ROCKFORD BOARD OF EDUCATION
INVITATION FOR BID ON SUPPLIES, MATERIALS, EQUIPMENT OR SERVICES
FOR SCHOOL DISTRICT NO. 205
ROCKFORD, ILLINOIS

RFQ No. **16-22 Riverdahl Elementary School Additions**

DATE: **Thursday, January 7, 2016**

RE: **ADDENDUM NO. 1**

1 ROOF POWER AND SYSTEMS PLAN
1/16" = 1'-0"

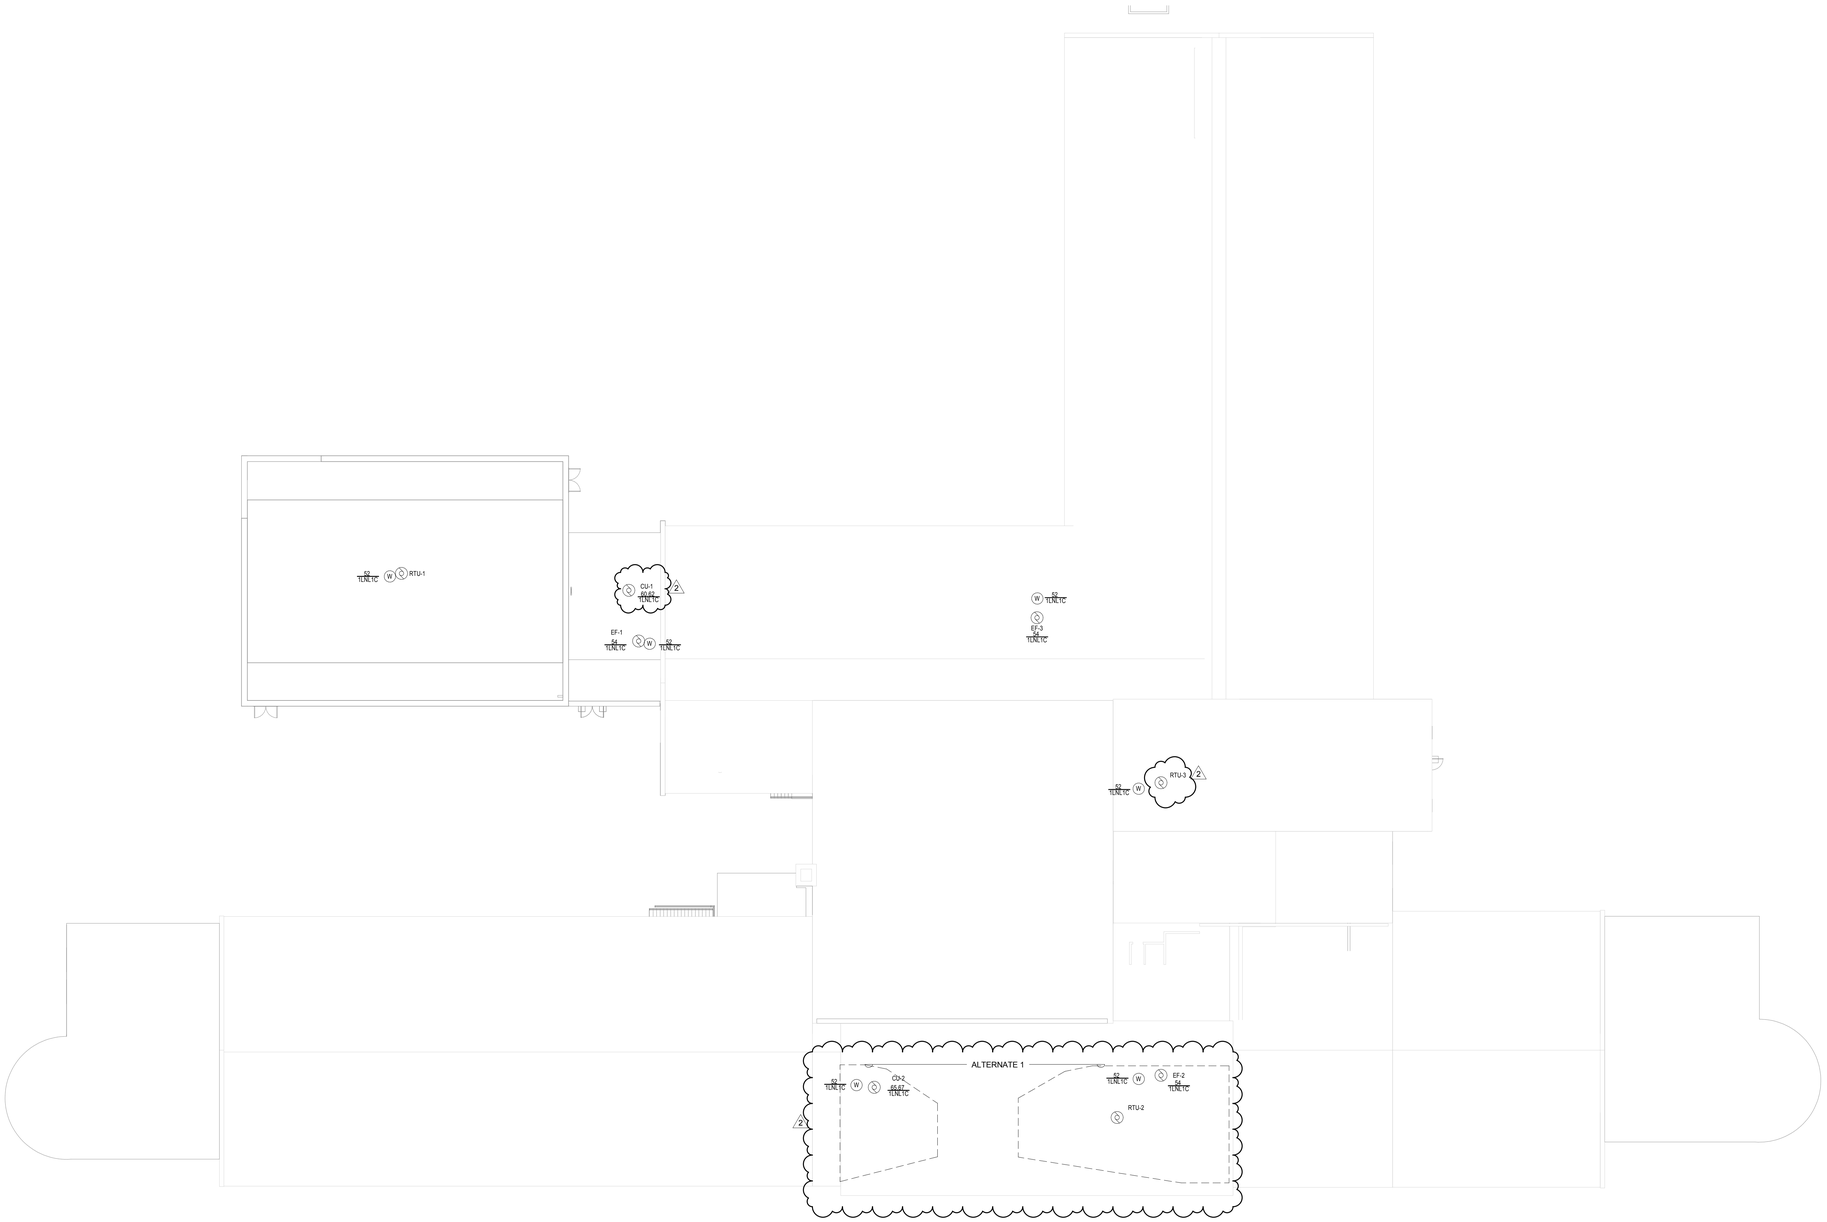
57. E0202 – ROOF POWER AND SYSTEMS PLAN

A. Added CU-1 connection.

B. Added RTU-3 connection.

C. Added Alternate 1 boundaries.
